**MADISON AND WAHSINGTON ELEMENTARY SCHOOL ADDITION & RENOVATION  
HURON SCHOOL DISTRICT 2-2  
HURON, SOUTH DAKOTA**

KOCH HAZARD ARCHITECTS

ADDENDUM DATE: March 12, 2014

**ADDENDUM-1**

PROJECT NO. <b>113059</b>	SHEET <b>RM1. 1</b>
DATE <b>03-11-14</b>	
DRAWN BY <b>EJS</b>	1 OF 5

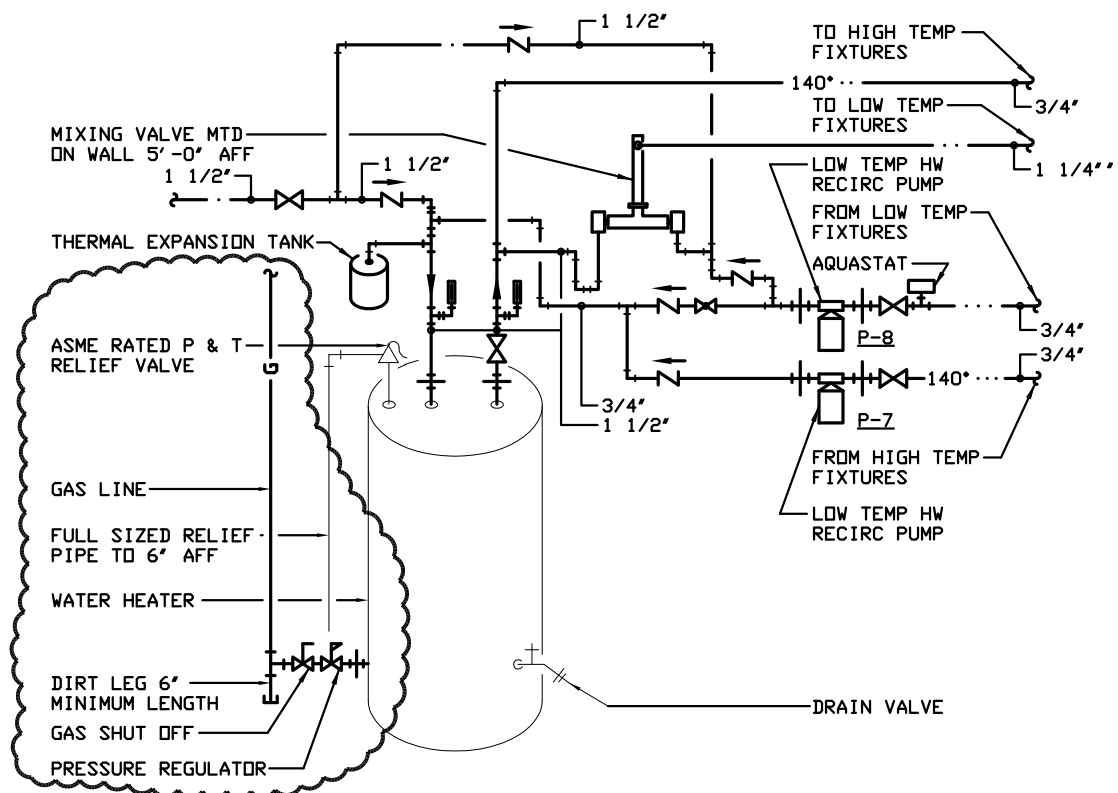
1. Added Gas piping to BOILER PIPING DETAIL and WATER HEATER PIPING DETAIL
2. See attached Drawing Sheet RM1.1, dated 3-11-14, sheet 1 of 5.

**RM3. 7**

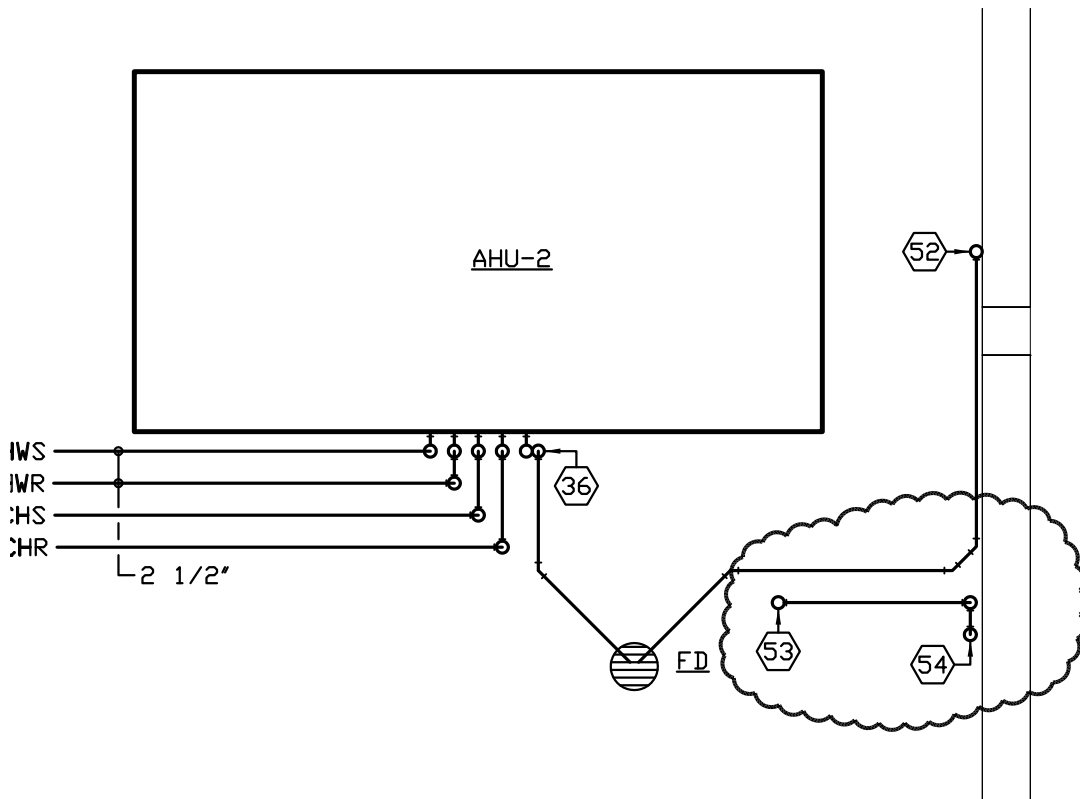
2. Added notes 53 & 54. See attached Drawing Sheet RM3.7, dated 3-11-14, sheet 2 of 5.
3. Added Vent piping in ENLARGED MEZZANINE PLAN – PLUMBING & HEATING. See attached Drawing Sheet RM3.7, dated 3-11-14, sheet 2 of 5.

SHEET  
**RM3. 7**  
**3 OF 5**

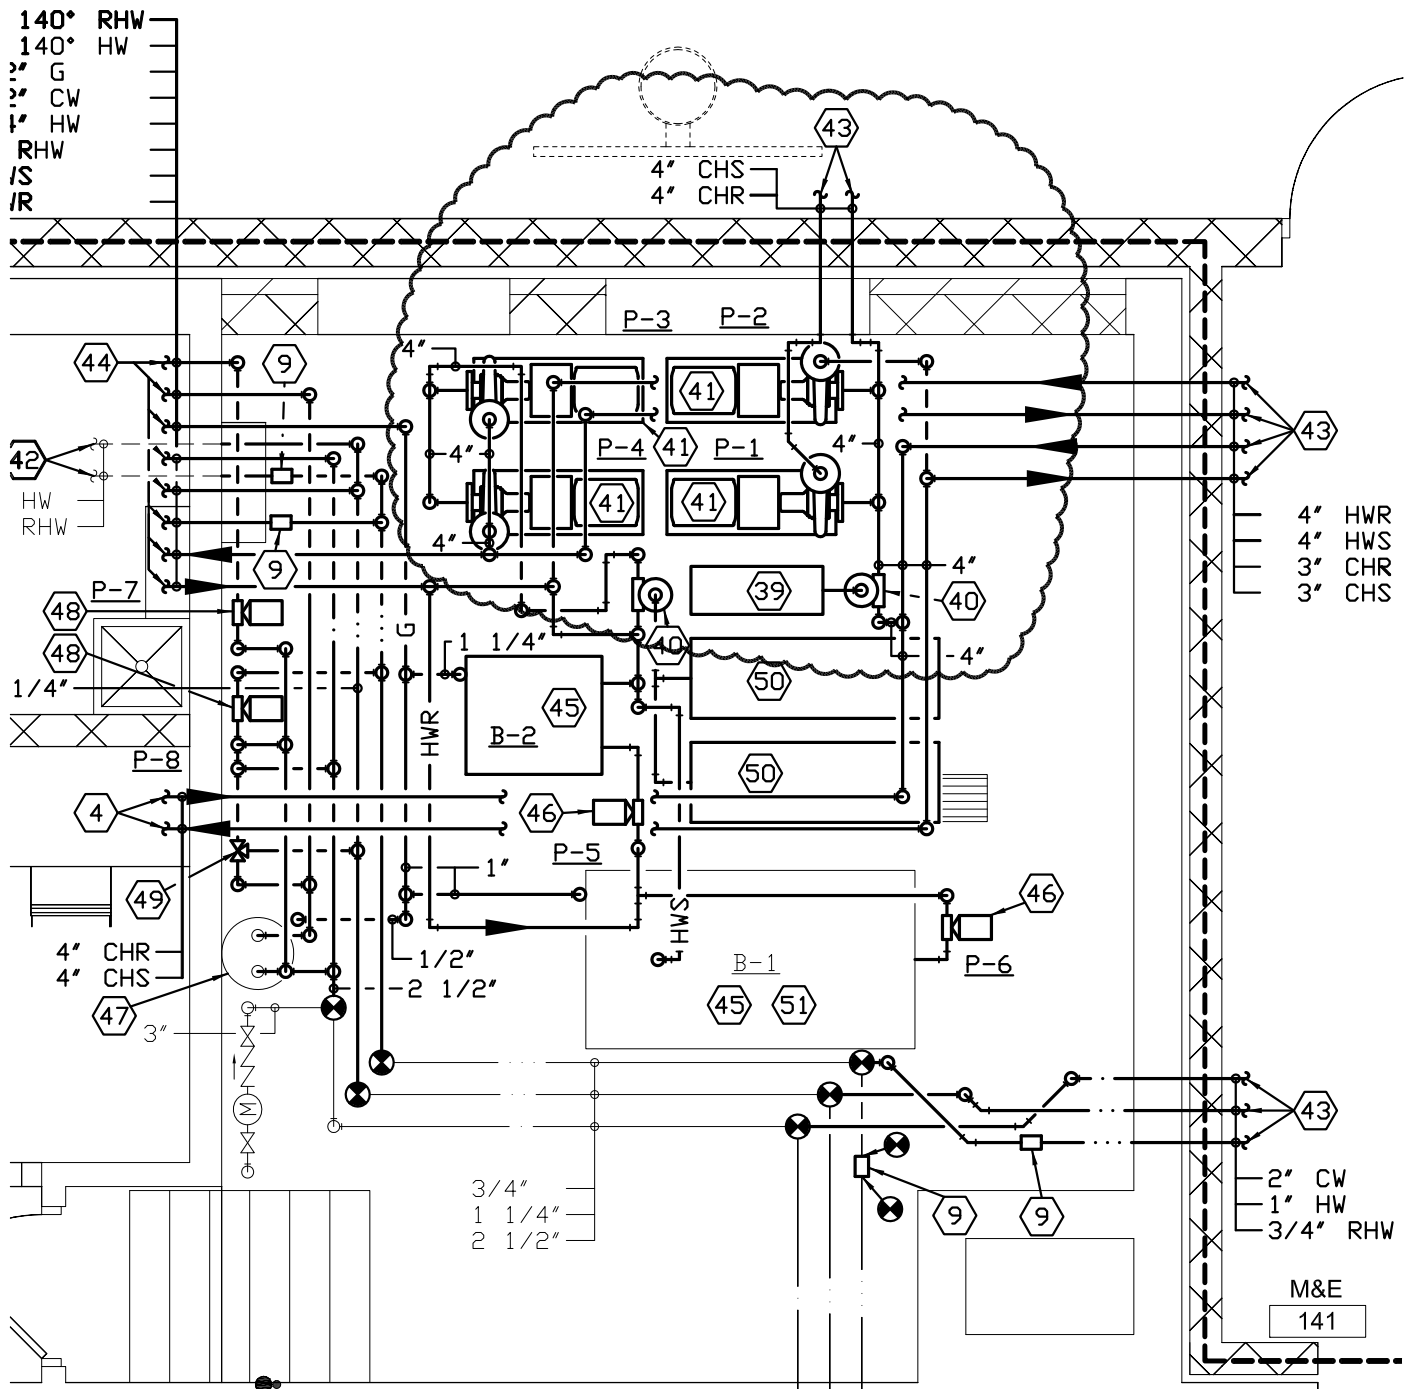
4. Revised CHS & CHR piping in ENLARGED MECHANICAL ROOM 141 PLAN – PLUMBING & HEATING. See attached Drawing Sheet RM3.7, dated 3-11-14, sheet 3 of 5.
5. Revised HWS & HWS piping size by pumps in ENLARGED MECHANICAL ROOM 141 PLAN – PLUMBING & HEATING. See attached Drawing Sheet RM3.7, dated 3-11-14, sheet 3 of 5.

SHEET  
**RE-1**  
 1 OF 1

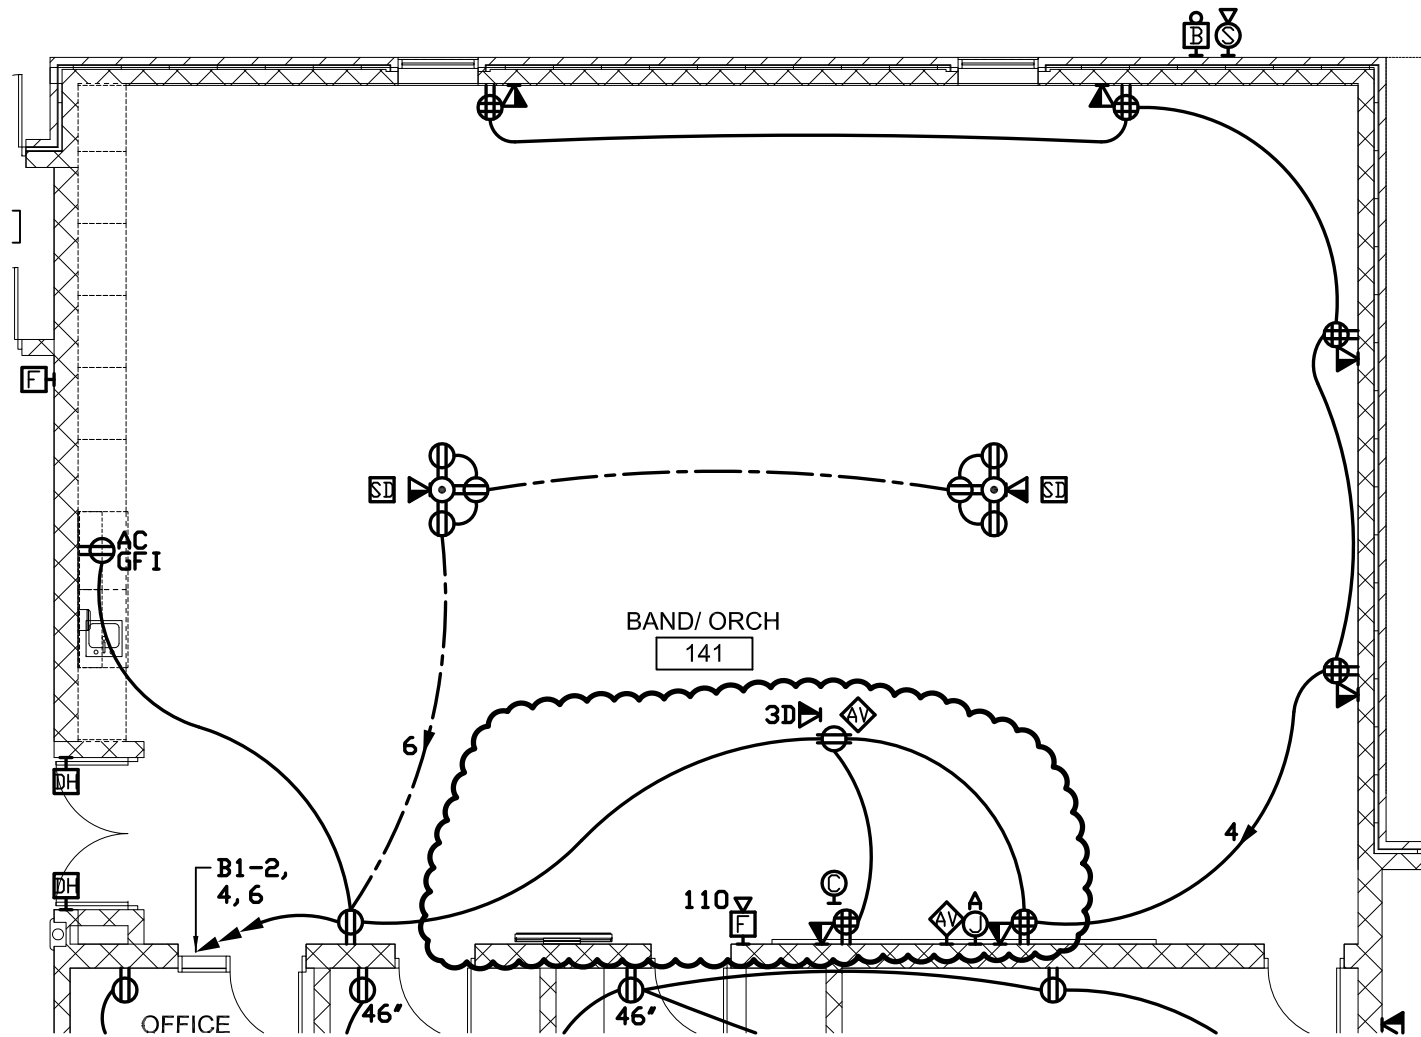
1. Exterior: Main Switchboard “MSB” shall be a Main Distribution Panel “MDP” in lieu of a switchboard. In order to accommodate construction phasing it may need to be pad mounted in lieu of mounted to the exterior wall of the gym.
2. Exterior: The chiller CH-1 is located just west of the utility transformer (see sheet M4.2 for location). Locate the chiller main disconnect switch on the exterior wall of the gym to the northeast of the chiller at the east end of the chiller.
3. Room 136: Provide two fire alarm smoke detectors. Center the fire alarm strobe on the west wall.
4. Room 141: See the attached revision drawing RE-1 dated 3-11-2014 for revised electrical layout.
